## **Chapter 1**

**Items 1-1-12 through 1-10-12**

**August 7, 2013.**

This is one of ten documents containing those proposed changes to the A117.1 Standard, 2009 edition; for which A117.1 Committee received Ballot or Proponent Comments. Each item was discussed at the meeting of Committee during the week of July 15, 2013, in Washington D.C. The Committee took action on each proposal and such action is specified herein. The actions listed here are subject reconfirmation by the Committee via the Committee's ballot process.

**Proposal 3-9 Excpt. 1**

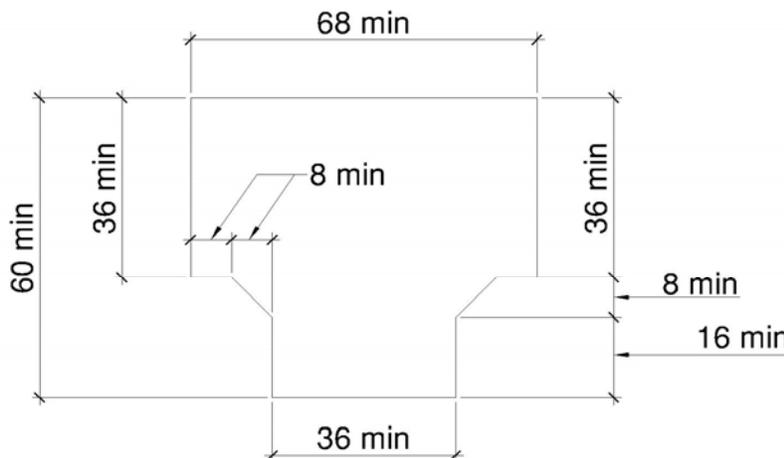
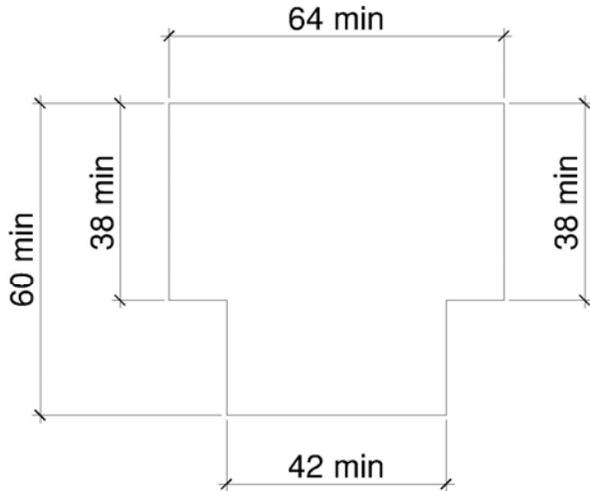
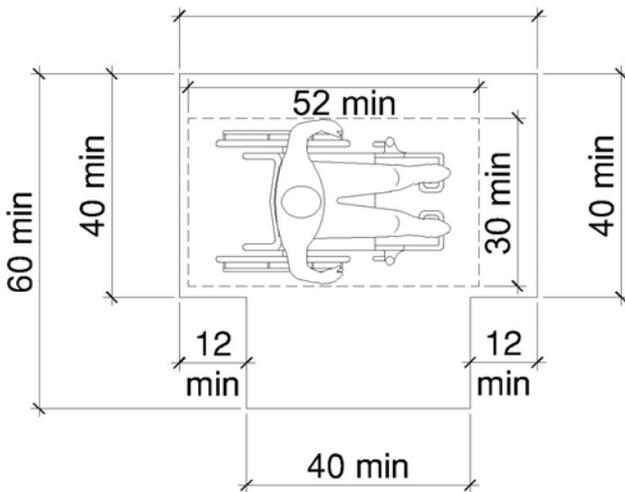
**Reason:** The Wheeled Mobility Task Group (WMTG) was created as a task group of the A117.1 Committee to analyze the results of the anthropometric study of a variety of mobility device users conducted by The Center for Inclusive Design and Environmental Access (IDeA) at the University at Buffalo, SUNY recently completed an anthropometric study of 500 wheeled manual and powered mobility device users. The study indicates that the technical provisions contained in the A117.1 standard do not address the needs of the full range of users of mobility devices. The work of the WMTG is ongoing, but it has submitted a series of proposed changes to the base building blocks of the A117.1 standard. If the changes to the building blocks are adopted by the Committee, then additional changes will need to be made in other portions of the standard.

**Committee Reason:** The Committee explored the various options and limitations for regarding making the T-shaped turn. While the dimensions shown in the figure labeled Proposal 3-9 were the base of the discussions, the Committee concluded that the 3 designs should be shown in the text (perhaps in a table) as 3 equal options for design the space. The Committee approved the figures; asked staff to develop text.

### 305.3, Figure 305.3, 305.7.1, 305.7.2

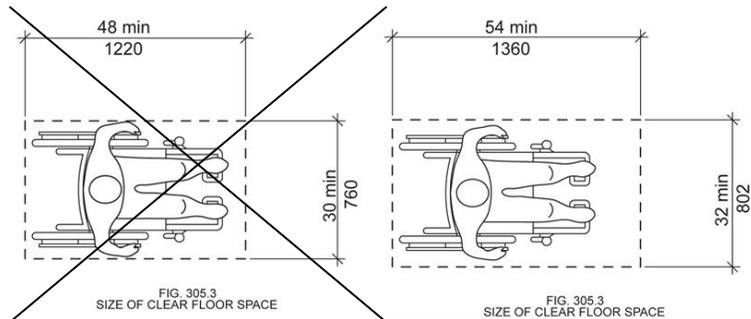
**Comment:** The standard dimensions have long been established based on the type of WhMD available at the time that the standard was developed. As more WhMD users purchase larger WhMDs, it doesn't justify need to increase the code and if it is permitted we will see ever. Similar to the last code cycle, the stair manufacturers brought studies trying to validate their proposed changes and were disapproved because their studies did not go out for peer review. In addition, fair housing references the 1986 ANSI A117.1 standards as the baseline which would make the argument that if the older reference standard is deemed a safe harbor, then there will be no reason to continue maintaining this document or to reference any newer version in the code. Proposal 3-13-12 was approved by a slim margin and NAHB disagrees with those members of the committee that would require dwelling units to accommodate these mobility devices that are primarily designed for outdoor use.

FIG. 306.2  
TOE CLEARANCE

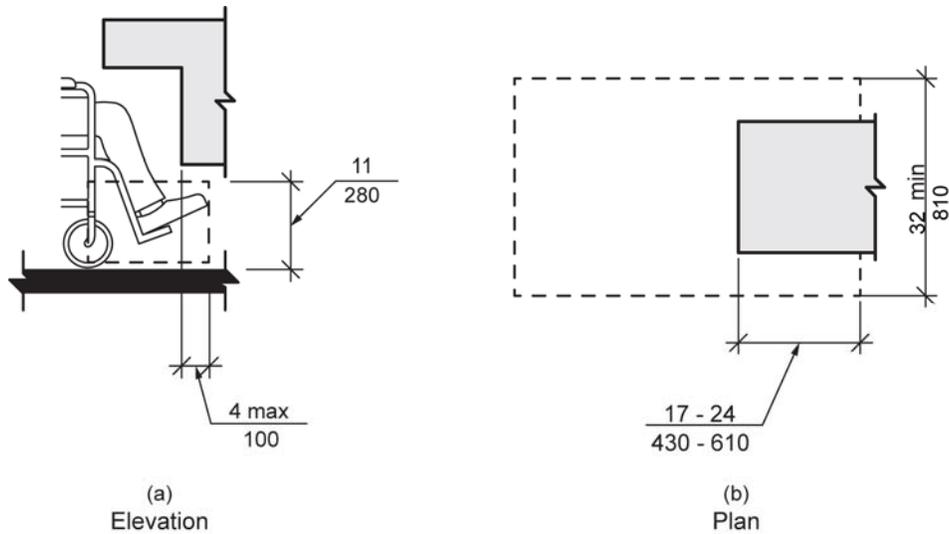
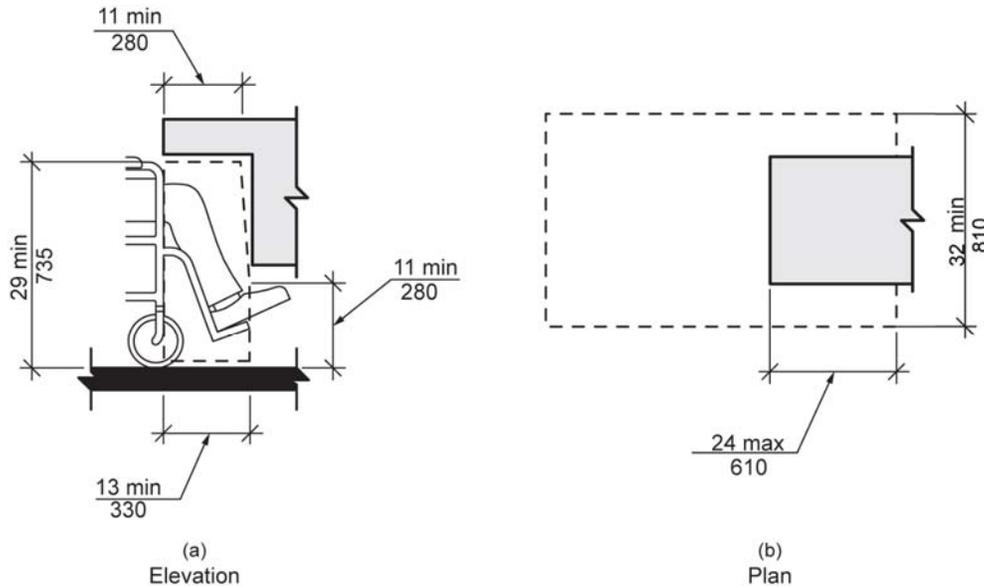
NOTE: This change necessitates a change to Fig. 306.2 and Fig. 306.3 to ensure consistency. Thus, the proposed revised figures have been attached, along with the existing figures for comparison purposes.

### 308.2.1, Figure 308.2.1

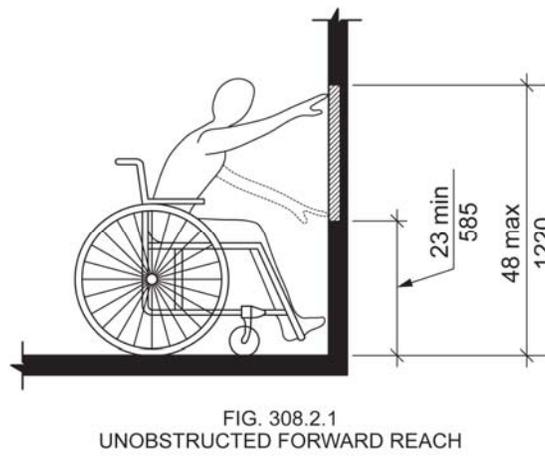
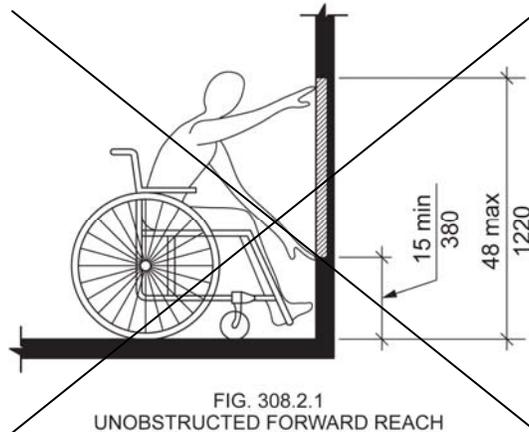
NOTE 2: This change necessitates a revision to Fig. 308.2.1 to ensure consistency. A revised figure is attached.

**Comment:** We not accept the results of a single anthropometric study conducted by the Center for Inclusive Design and Environmental Access. It is understood that the work of the Wheelchair Mobility Task Group is ongoing and has submitted a series of proposal changes to the base building blocks of A117.1 Standard. At this time we believe that the proposed changes to the building blocks are unacceptable and should not be adopted by the Committee; therefore no additional changes are required in this portion of the standard with reference to the building block changes.

FIG. 308.3.1  
UNOBSTRUCTED SIDE REACH

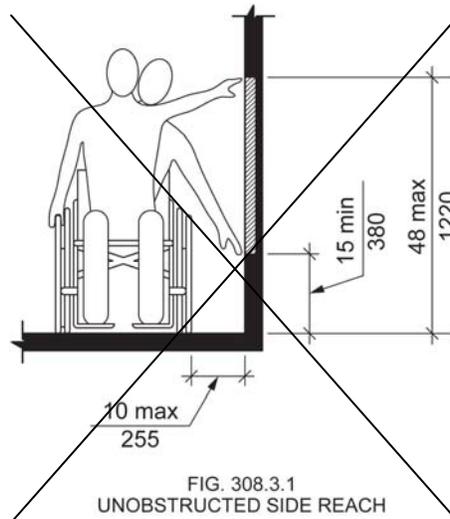
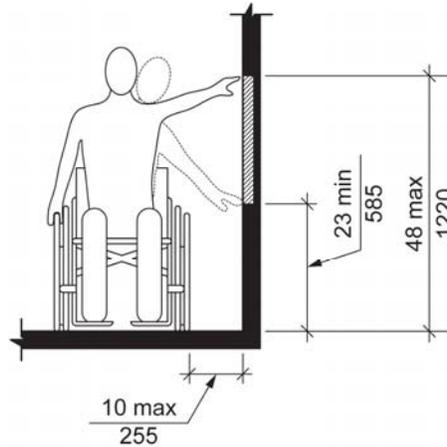
NOTE 2: This change necessitates a revision to Fig. 308.3.1 to ensure consistency. A revised figure is attached.

**Comment:** The AHLA does not accept the singular results of the anthropometric study conducted by the Center for Inclusive Design and Environmental Access. It is understood that the work of the Wheelchair Mobility Task Group is ongoing and has submitted a series of proposal changes to the base building blocks of A117.1 Standard. At this time we believe that the proposed changes to the building blocks are unacceptable and should not be adopted by the Committee; therefore no additional changes are required in this portion of the standard with reference to the building block changes.

The following is Figure 404.2.3.2(e) from the A117.1-2009 standard.

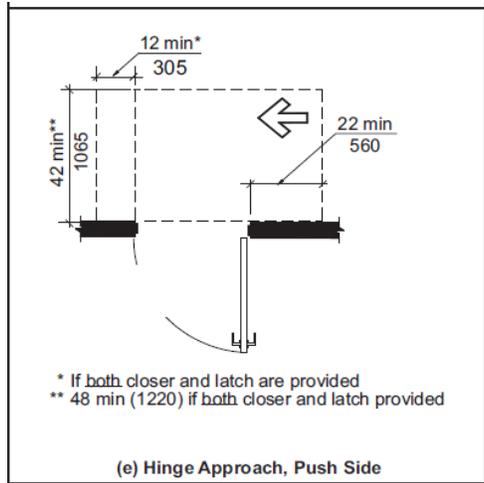
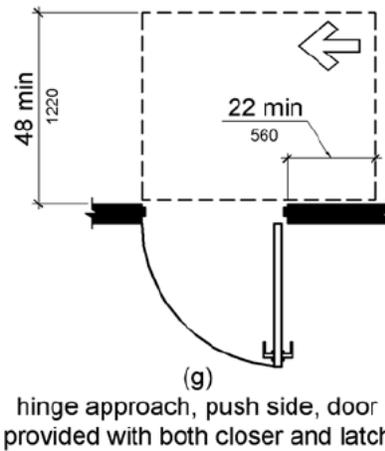
The A117.1 requires there 12 inches beyond the latch side on this door if both a closer and a latch are provided on the door. The ADA does not have this 12 inch requirement.

This requirement was added to the A117.1 standard between the 1998 and 2003 editions by proposal 4-015 and was modified by public comment that cleaned up the footnote reference for it. The proponent's reason statement said that figure (b) the front approach push side and figure (e) the hinge approach push side are similar situations and that having the 12 inches on the forward approach should also be provided on the hinge approach.

Because this extra requirement creates a discrepancy between the A117.1 and ADA which is not readily apparent and well known, the elimination of the footnote reference would help to coordinate the two standards and make this basic issue of door maneuvering clearances consistent. It seems that the addition of this requirement was probably not well justified when it was added into the 2003 A117.1 standard and with the change made in Section 404.2.3 of the 2009 edition which prevented door maneuvering clearances from including knee and toe clearance it made the difference between the A117.1 and the federal requirements that much greater. With some of the task groups looking at changing the 'building blocks' which could further affect maneuvering clearances, it would seem that this difference between the two standards should be eliminated or better justification should be provided so that it could be added into the federal requirements and coordinated that way.

The graphic representations of the various layouts are provided to better illustrate the differences. In the 2009 standard it is Fig 404.2.3.2(e) and in the 2010 ADA it is Figure 404.2.4.1(g). See ADA figure 404.2.4.1(f) for base condition.

FIG. 607.2(b)  
CLEARANCE FOR BATHTUBS

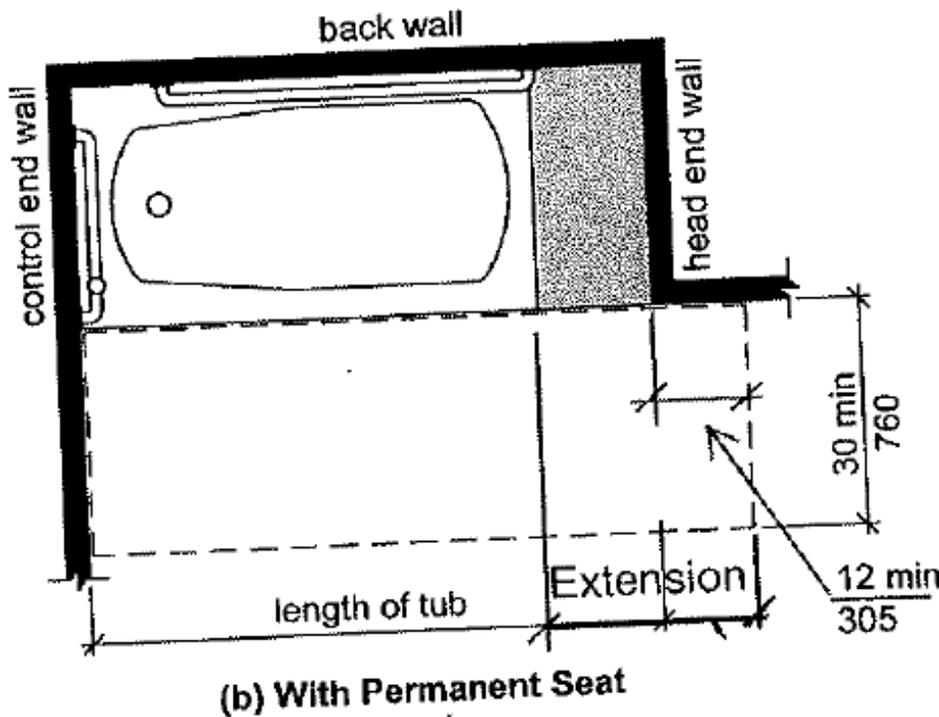
Section 607.4.1 sets the 'depth' of the seat. The current language skips the piece between the 'length of the tub' and the end of the extension. This is a technical issue that just gives you all the pieces. Please see graphic revision attached.

**Comment:** The permanent seat and extra 12" beyond needs better description.
